ADDENDUM #1
IFB# 2020-0098-PW/KE
LA PUEBLA FIRE STATION

LA PUEBLA FIRE STATION ADDITION
LA PUEBLA, NEW MEXICO
Addendum #1
SKA-101.01

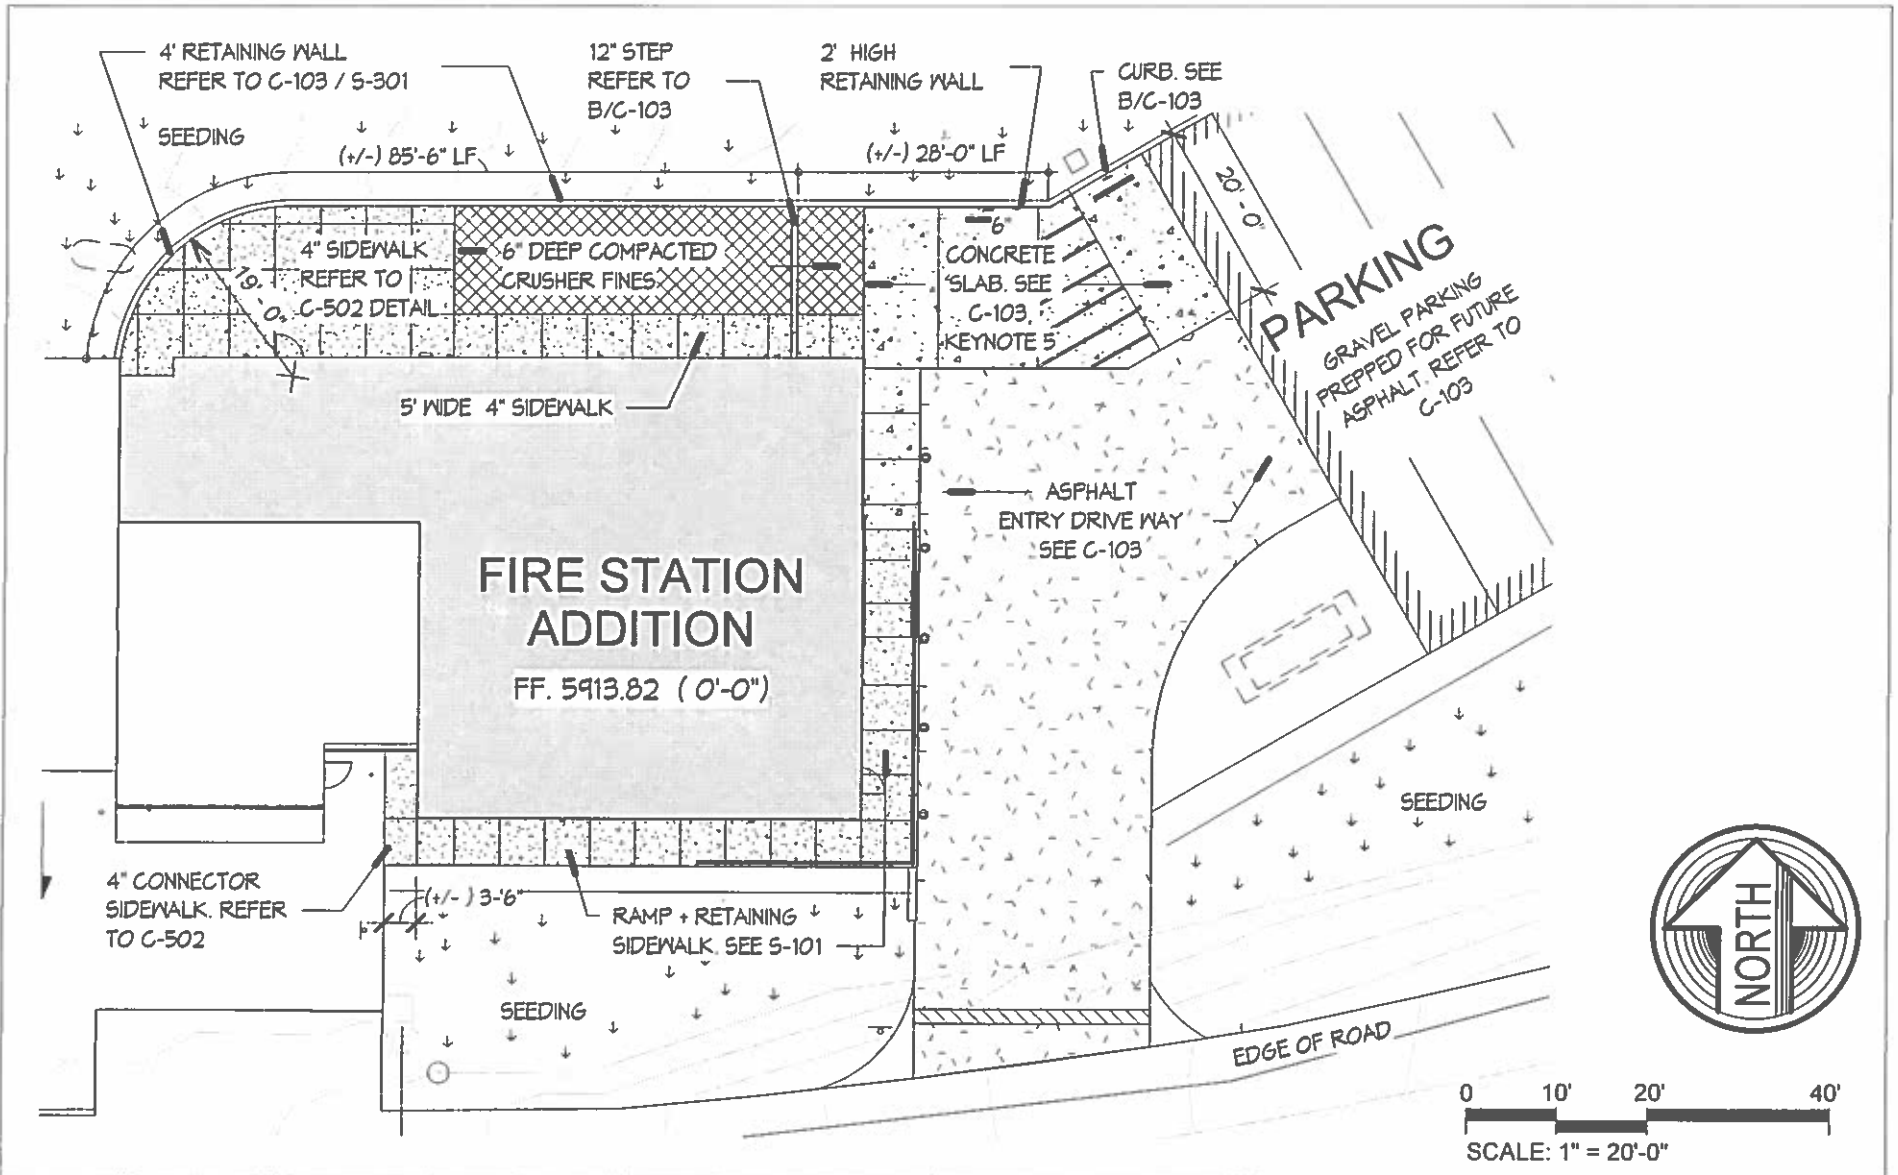
9. At the patio in the rear of the building between the retaining wall and the building – is all of it concrete or just parts of it concrete? If just part concrete, what parts?

ANSWER: Refer to SKA-101.01 for paving and ground cover clarifications. (Attached)
